Comments by the NRC staff (2-26-2003) on the
EXECUTIVE SUMMARY, prepared by Sandia on 2-19-2003

Comments by the NRC staff (2-6-2003) on the Structural Analysis Approach for the Examination of a Jetliner Impact onto the NUHOMS-32P, VSC-24 and TN-68 casks, prepared by Sandia on 2-20-2003

Figure 1. HI-STORM ^{100 storage} cask.

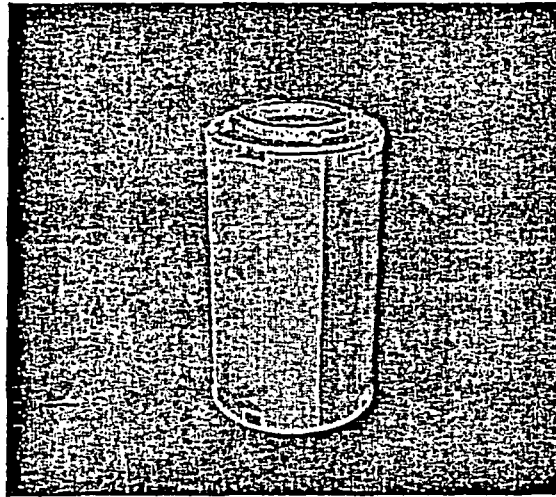
*Should we
(not specify)
Ex.*
